**Assessment of Hydrogeologic Conditions and  
Need for Long-Term Groundwater Monitoring  
at the Former Durita Uranium Mill, Naturita, Colorado**

**Executive Summary**

Gene Peters and Randall Fedors

Gene Peters and Randall Fedors

Figure 7. Topographic Map of Durita Site Showing Monitoring Wells. Modification of Downloaded File Obtained from Topozone™ on 07/17/2006.

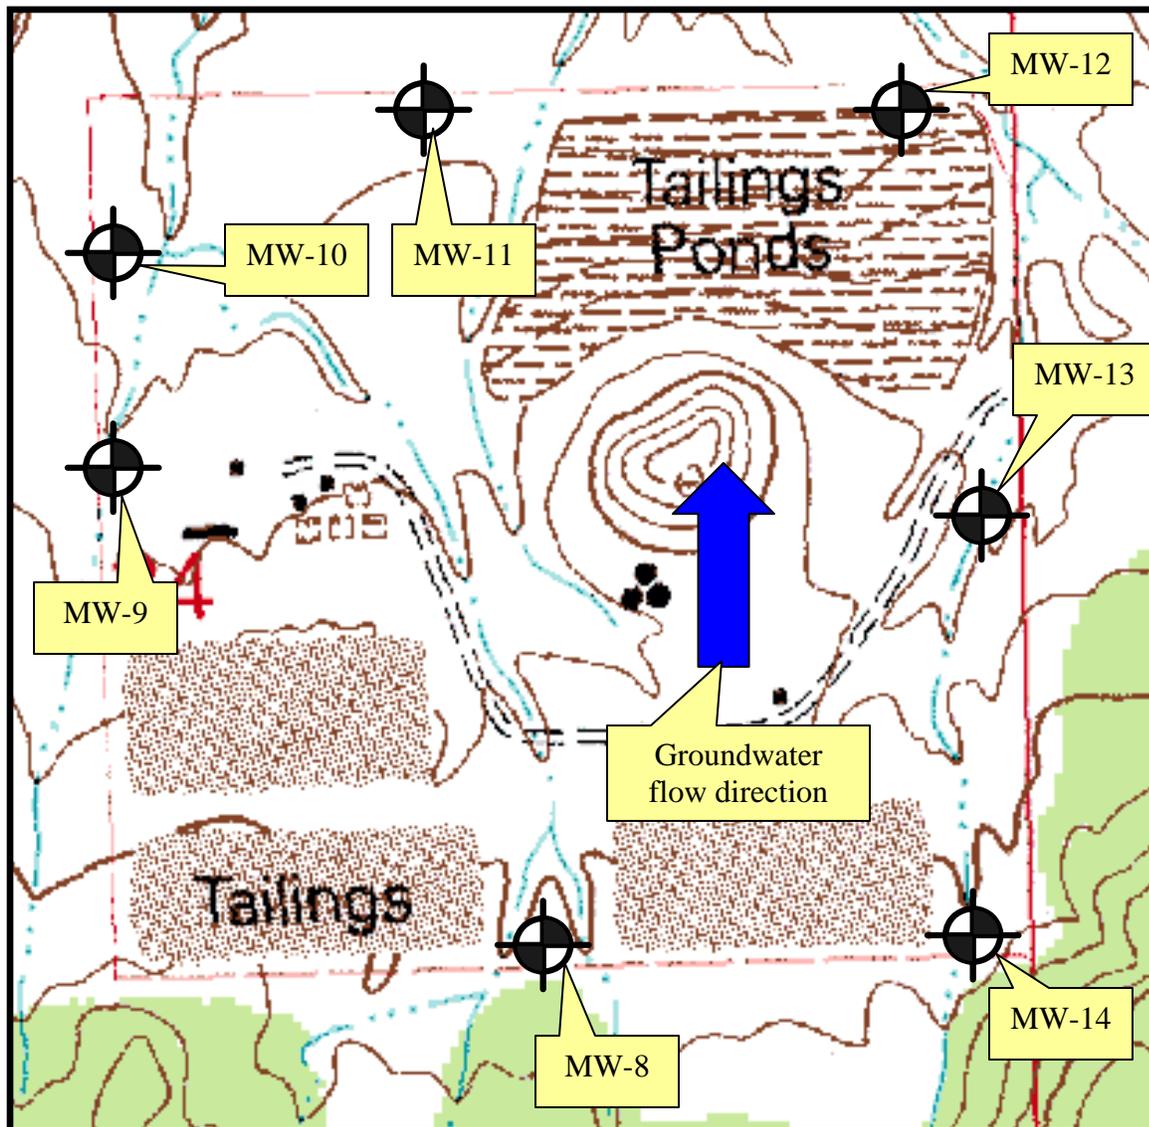
The gradient of the water table is northward towards Dry Creek, but is ill-constrained because it is only defined by seven wells installed along the property boundaries. The seven boreholes outlining the permit area (Figure 7) were drilled into the uppermost aquifer, cased, and screened for monitoring purposes. The monitoring wells are labeled MW-8 through MW-14. The screened intervals intersect the sand layers in the lower portion of the Mancos Formation. Wells MW-1 through 7, mentioned in Fox (1982), were completed during leaching operations in the late 1970s. These wells, however, were improperly completed; thus no data were reported in the available documents.

Of the seven wells monitoring wells constructed in the early 1990s, three are designated as downgradient monitoring wells (MW-10, -11, and -12), two are cross-gradient wells (MW-9, -13), and proximal to sources, and two are upgradient background monitoring wells along the southern Site boundary (MW-8, -14).

**Figure 8. Potentiometric Heads for Upstream Boreholes From Two Data Sources, Hecla (1998) and Studios Solutions (1994)**

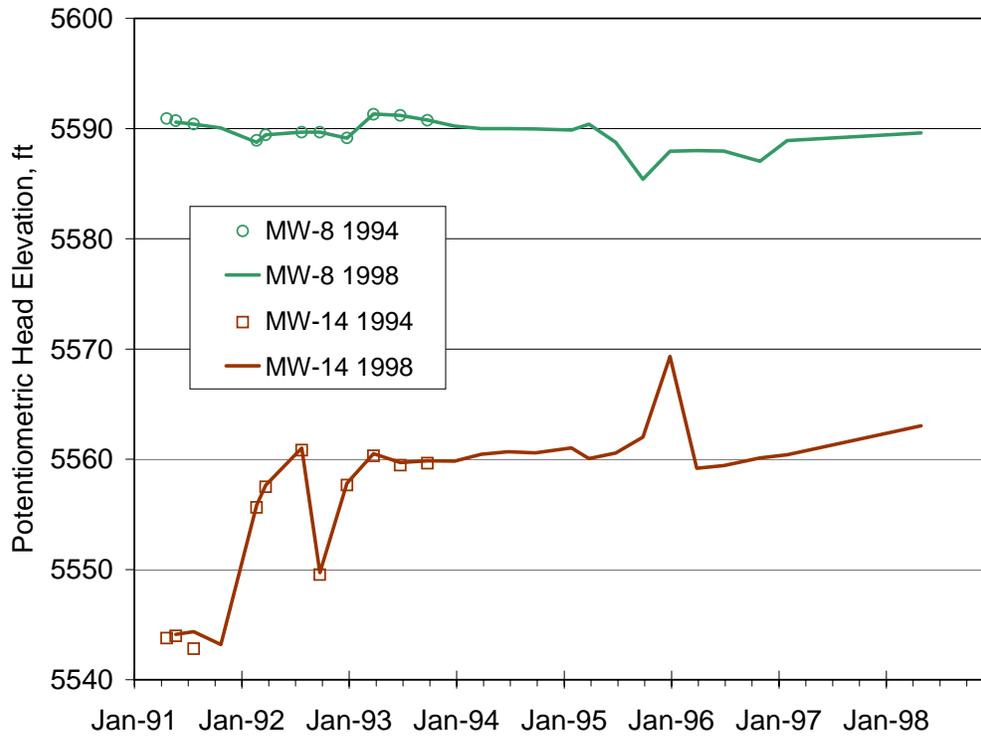
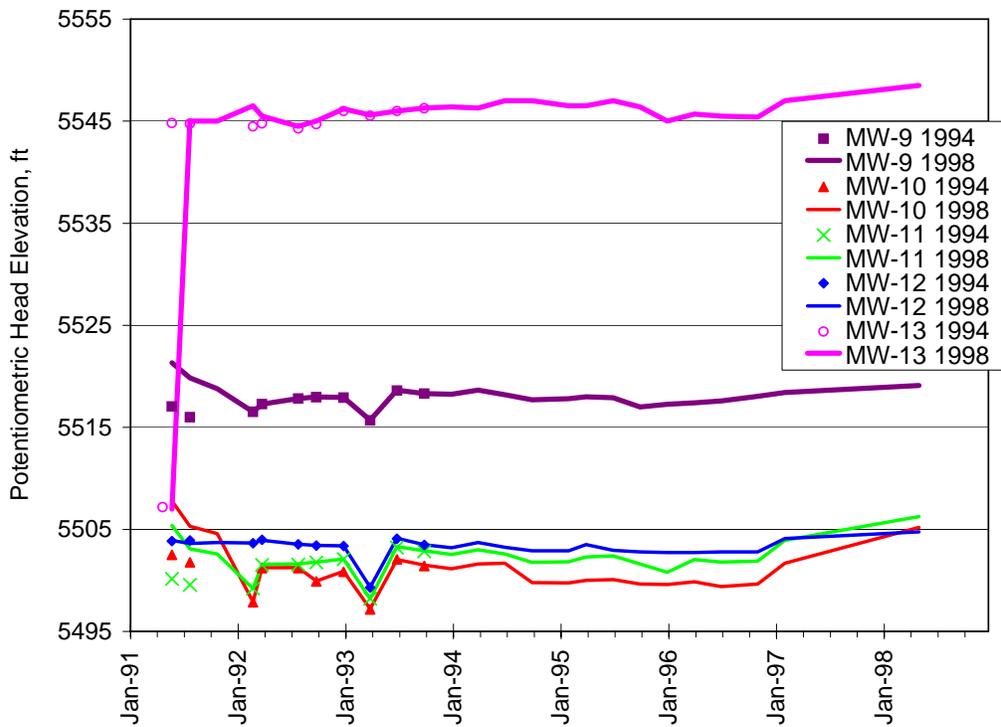
Water levels during the reclamation period, 1992 and 1993, are highly erratic. A prominent downward spike occurred in six of the eight wells late in 1992 (Figures 8 and 9).

The implication is that ground surface activities at the site impacted the water levels. One hypothesis, if preferential flow pathways are presumed to exist, is that re-grading or diversion channel development may have temporarily clogged the flow pathways. Other explanations may be just as reasonably postulated; regardless, it is clear that ground water levels were affected by surface reclamation activities.

**Figure 10. Smoothed Quarterly Precipitation Overlaid on Potentiometric Head Data for Upstream Wells**

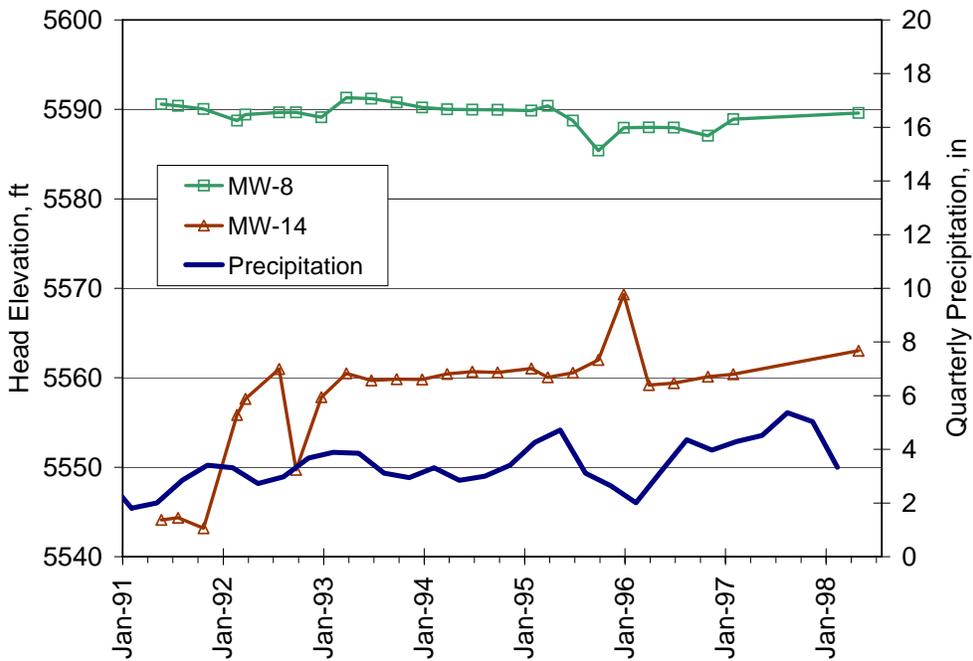
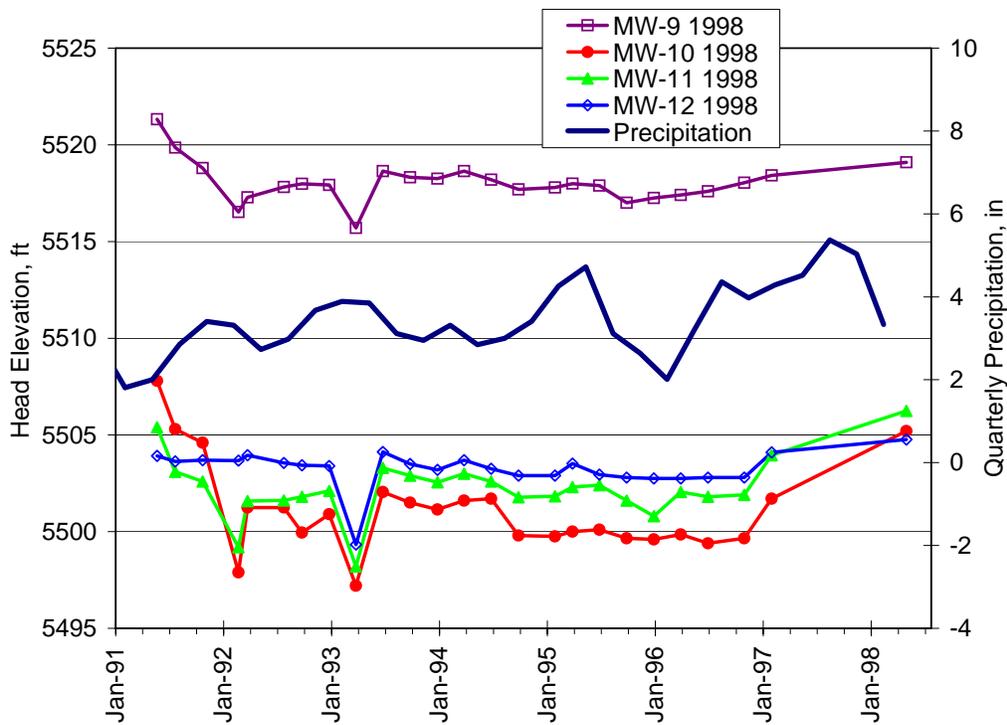
Temporal variations caused by climate stresses are evident when precipitation patterns are overlaid on the water level data (Figure 10 and 11). Two prominent observations are evident. First, a seasonal precipitation pattern is tracked by the water levels, particularly the downgradient (MW-10, MW-11, MW-12) and cross-gradient wells (MW-9 and MW-13). There is a significant dampening of the precipitation signal, and a slight delay in the propagation of the signal. The second prominent observation is that all the wells show an increase in water levels corresponding to the wetter years of 1996 and 1997. The aquifer response to the increased precipitation varies across the site from +1 to +5.5 ft from Nov 1996 to Jan 1998. Note that this period only has three measurements, so seasonal signals are lost. The spatial variation in the seasonal pattern supports a local source for the recharge, rather than an upslope recharge where the sand units intersect the ground surface (related to the synclinal structure). For example, MW-9 and MW-10 are closely spaced with MW-9 upgradient from MW-10. These two wells show the largest and smallest increases over the 1996 to 1998 period; MW-9 increased by 1.0 ft and MW-10 increased by 5.5 ft.
